V. C. SUMMER NUCLEAR STAION

EXAM NO. 50-0395/2000-301

LICENSEE POST-EXAM COMMENTS

SUBJECT: VIRGIL C. SUMMER REACTOR OPERATOR AND SENIOR
REACTOR OPERATOR INITIAL EXAMINATION FORMAL
COMMENTS

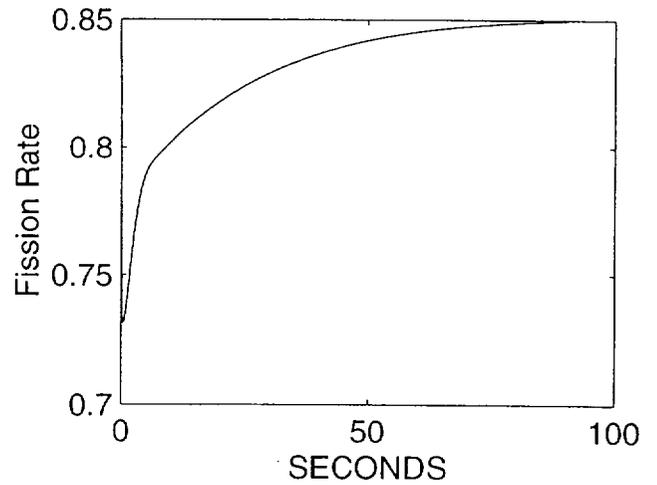
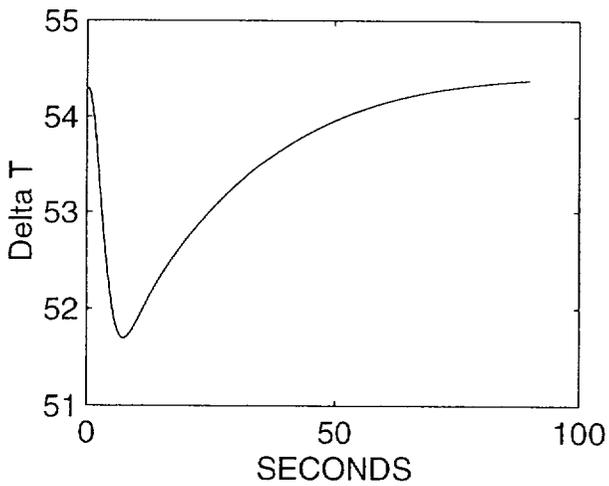
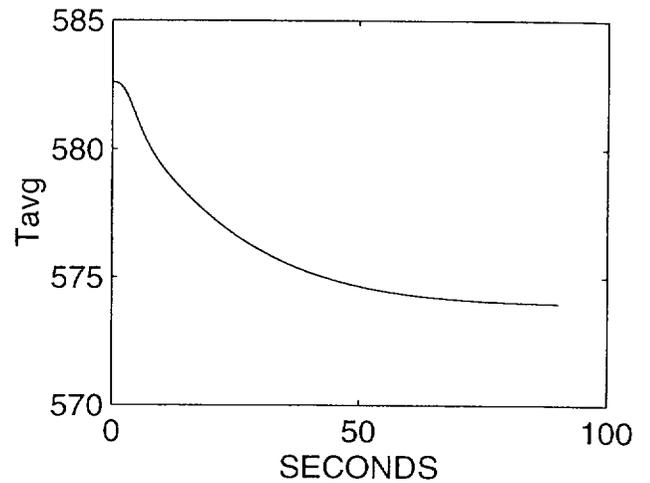
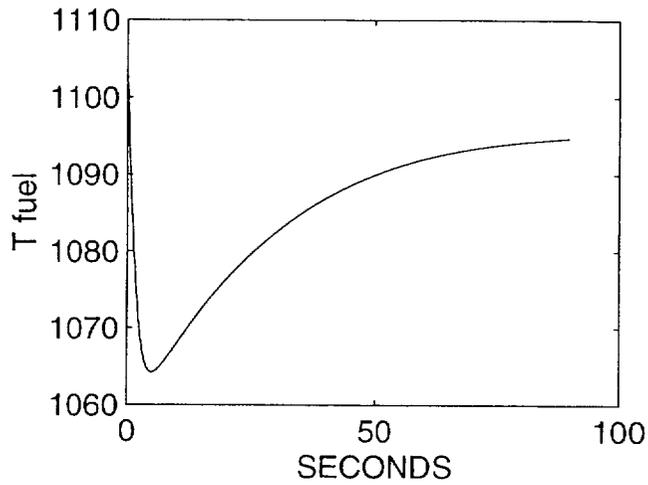
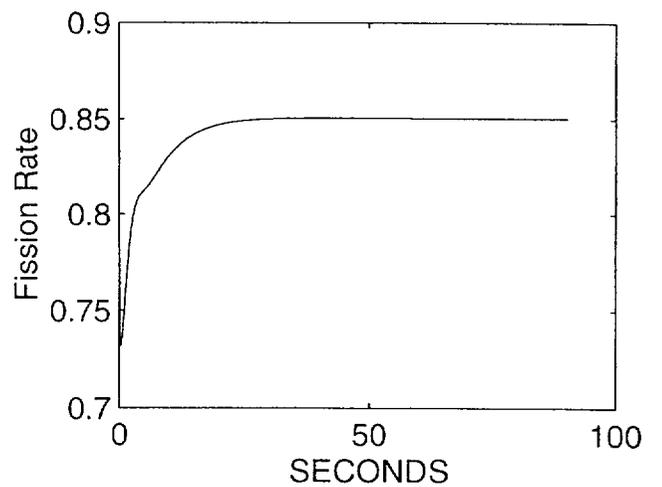
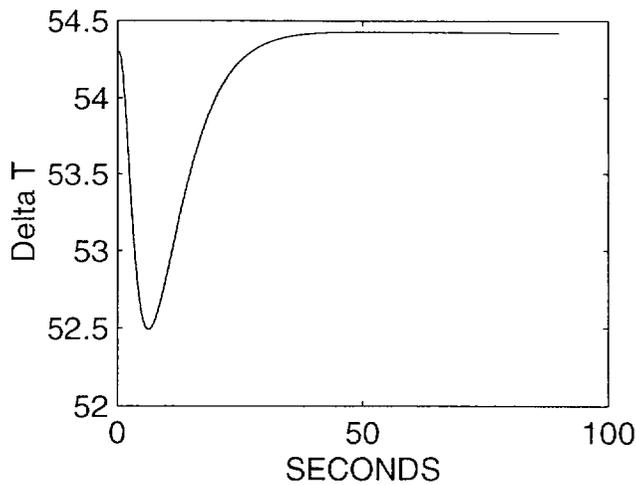
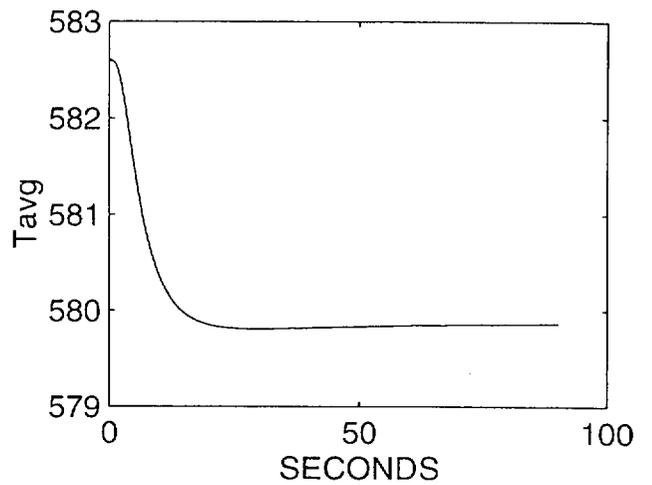
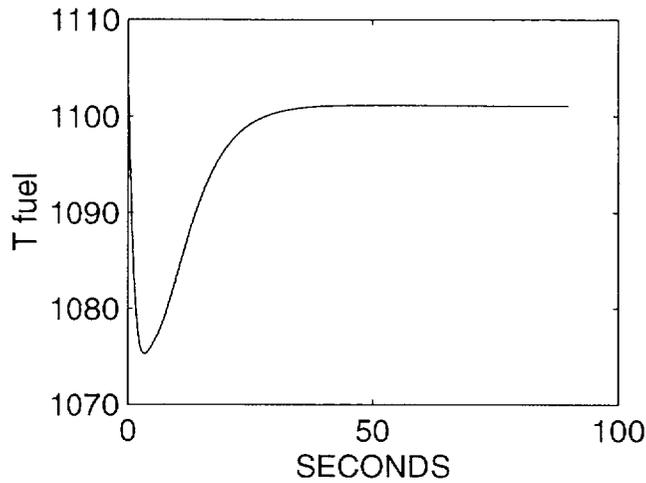
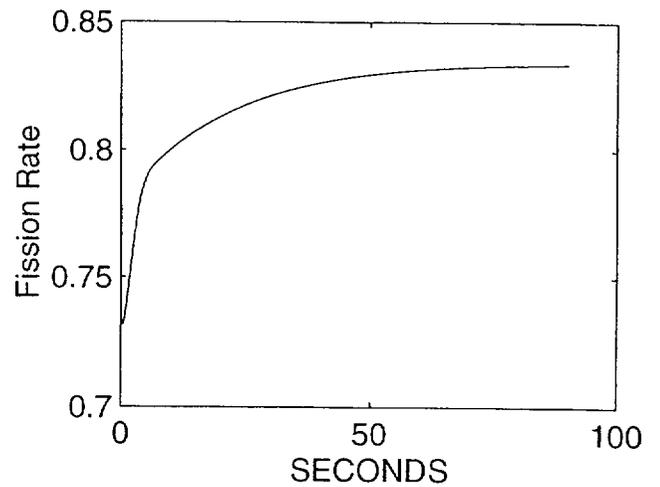
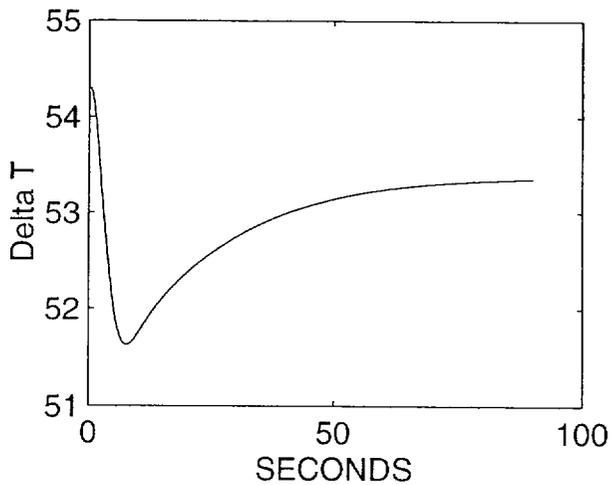
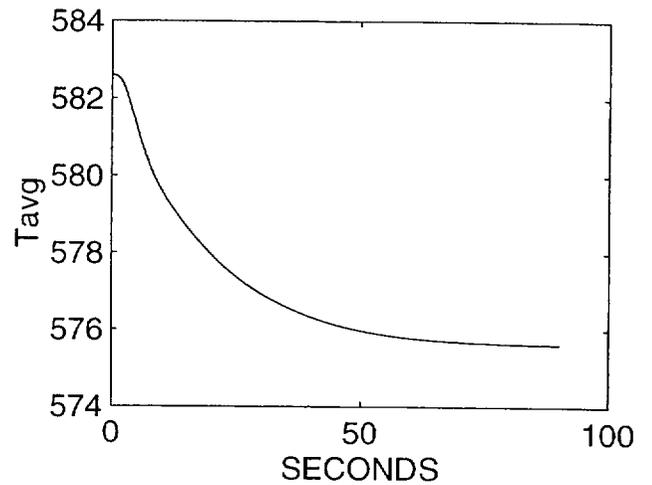
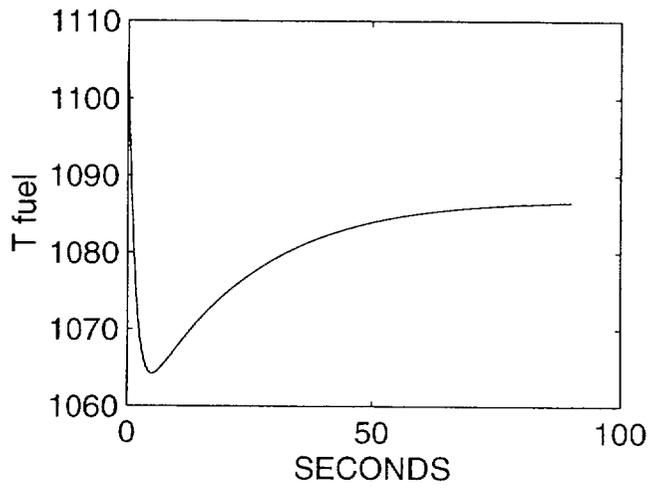
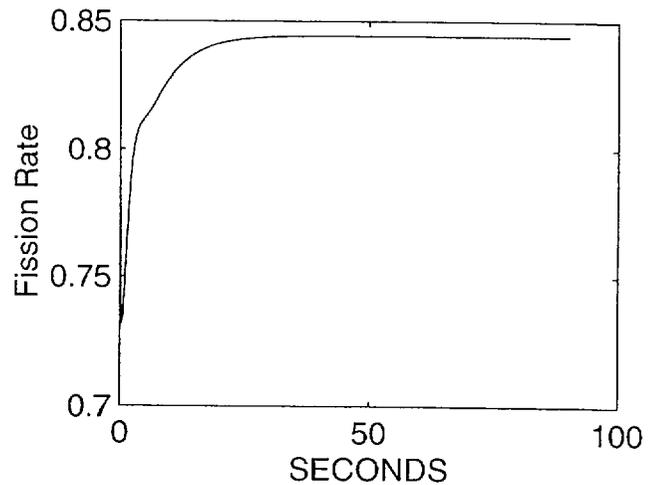
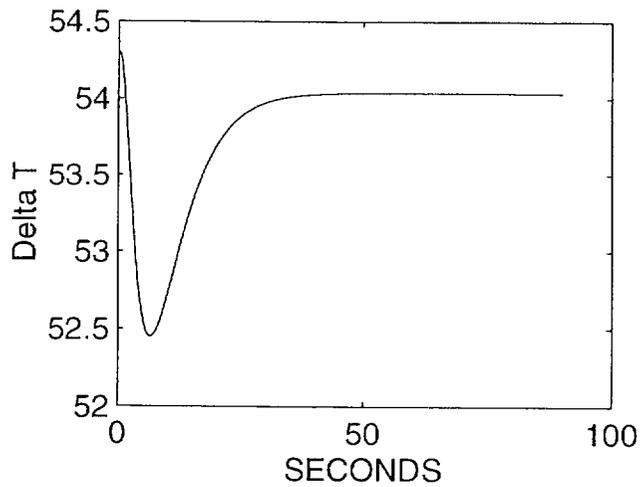
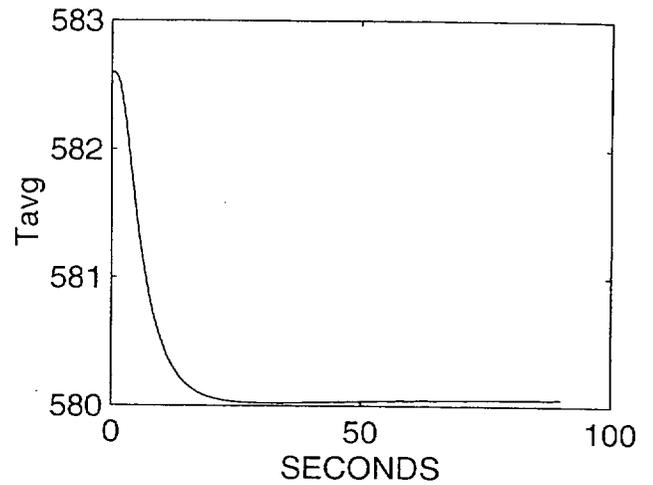
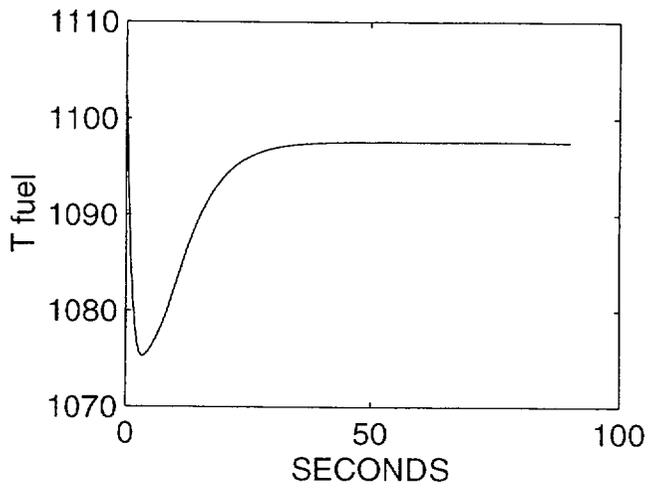
The attached graphs reflect the impact of dropping rod H2 on T_{fuel} , ΔT , T_{avg} , and power. Figures ① (BOL) and ② (EOL) with a constant secondary power (therefore, constant 1st stage pressure and constant T_{ref}). At BOL, T_{avg} changes by 7.5°F and at EOL, T_{avg} changes by only 2.5°F. In both cases, power returns to the original power level, which is a function of steam demand.

Figures ③ (BOL) and ④ (EOL) show similar results with a slight affect on steam pressure. The final power level is only slightly less than the original power level, therefore the impact on T_{ref} (1st stage pressure) is relatively small.

Accept either choice A. OR B.

FIGURE: VI-21
 REVISION DATE: 7/26/82
 CHECKED BY: *W. J. Clayton*
 APPROVAL: *ASB*

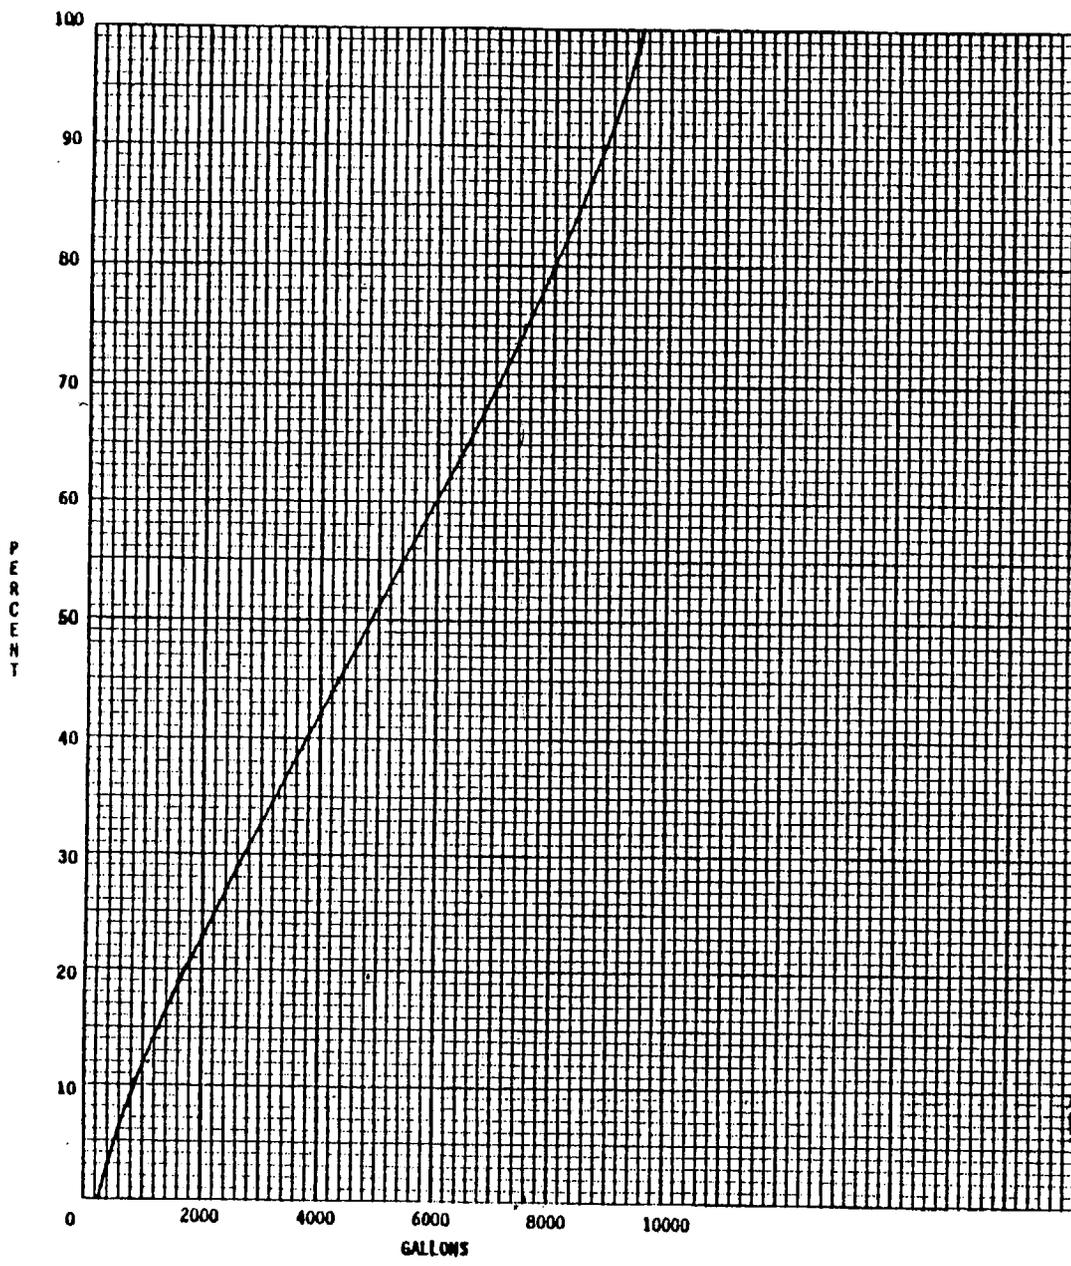
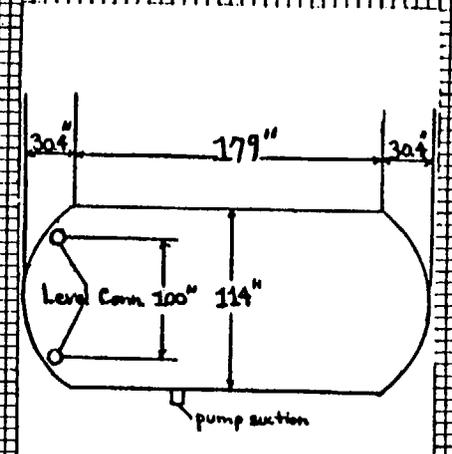
RCDT Level: Accept deviation of 21.0-24.0 gallons based on readability of curve VI-22 – Minimum/maximum value for 60% is 215/218 gallons, minimum/maximum value for 66% is 236/239 gallons for a minimum difference of 21.0 and maximum difference of 24.0.

If student obtains/calculates values within this range and performs Part 2 calculation correctly, and gives proper recommendation based on their calculated values of identified and unidentified leakage, they should receive full credit. Any values outside of the proposed grading for Part 1 or miscalculation or incorrect recommendation should result in less than full credit.
